THE DISTRICT AT SOUTH BAY
SPECIFIC PLAN PROJECT

JANUARY 2018

FINAL SUPPLEMENTAL ENVIRONMENTAL IMPACT REPORT

FINAL SUPPLEMENTAL ENVIRONMENTAL IMPACT REPORT

Figure IV.B-6a
Conceptual Sign Locations – Option A

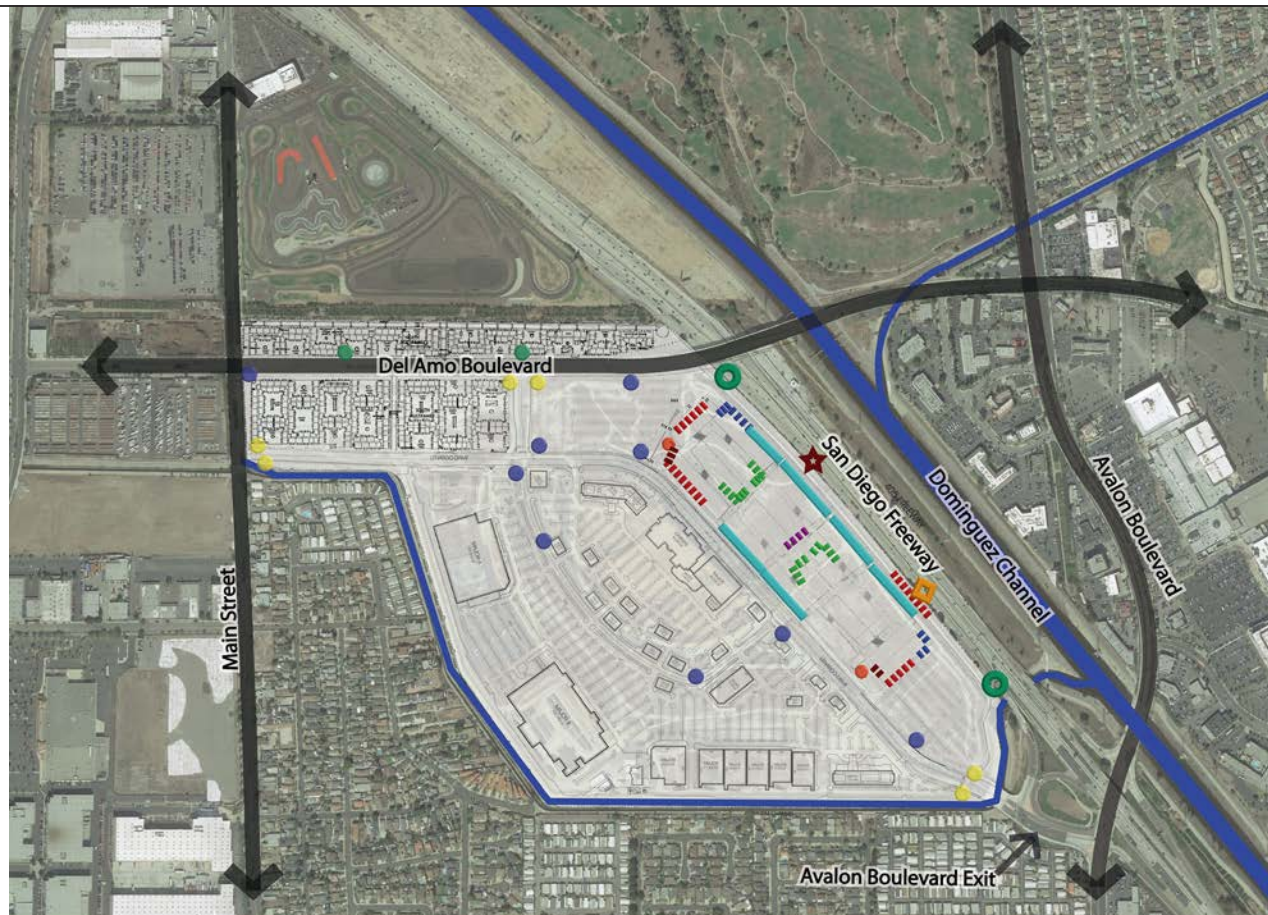
“**Signage:** The proposed modified Project will provide a hierarchy of signs similar to the approved Project, with some modifications. As further set forth in SPA Section 6.6, there are two options presented for freeway pylon signs for the proposed modified Project. Under the first option (Option A), there will be four freeway pylon signs, of which two will have a two-sided LED digital display with changeable message display and color changing illumination and two will be static signs. In the second option (Option B), there will be three pylon signs, each with a two-sided LED digital display with changeable message display and color changing illumination. Under either option, there will be an 88-foot maximum height above the I-405 Freeway grade—the proposed modified Project will feature four freeway pylon signs of which two will be static digital signs with a maximum height of 7088 feet above the I-405 Freeway, one will be of the same height but may include two-sided digital display, changeable message display, color changing illumination and electronic message display and a fourth two will be with a two-sided LED digital display with changeable message display, color changing illumination and electronic message display, and with an 88-foot maximum height above the I-405 Freeway.⁴ Up to ~~12~~nine Vertical Project Name ID signs (~~38~~15-foot maximum height) may be permitted, ~~a maximum of two of which may be constructed along the Main Street frontage.~~ Other project Entry Monument signs may be up to 38 feet in height. Other project identity signs and wall-mounted signs and billboards, ranging in height from 6 to 30 feet, may be mounted on walls or roofs per Table IV.B-1, General Sign Standards. Figure IV.B-6a, Conceptual Sign Locations—Option A, and Figure IV.B-6b, Conceptual Sign Locations—Option B, shows the conceptual sign ~~plan~~ locations.

a. Volume I, page IV.B-18, Figure IV.B-6, Conceptual Sign Locations.
